Keystone RV Company

SAFETY ADVISORY # 18-333

Cruiser Volante Awning Switch

Fig. 1

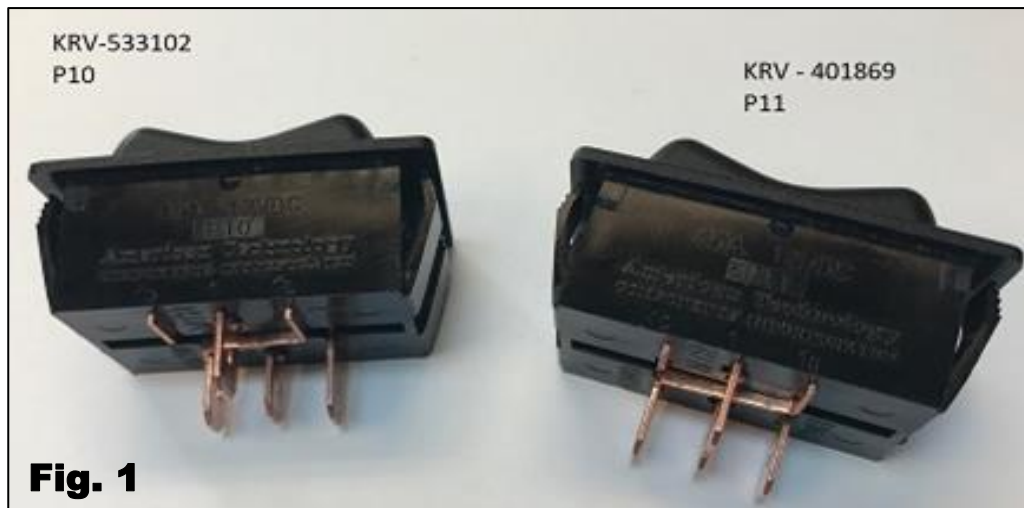
Keystone is conducting a voluntary RECALL notification campaign in accordance with the National Highway Transportation and Safety Act. It has been determined that the vehicles in the recall population may have been manufactured with an incorrect awning switch. This condition will allow the awning to continue to unroll after the switch is released. Under certain conditions during travel, if the awning motor is allowed to unroll it can unfurl leading to an increased risk of property damage or injury.

The remedy is to remove the P11 awning switch and replace it with a P10 awning switch (533102), Figure 1.

Parts Required: 1 – KRV # 533102 - Switch - 4 Terminal - For Slideout & Awning - Black
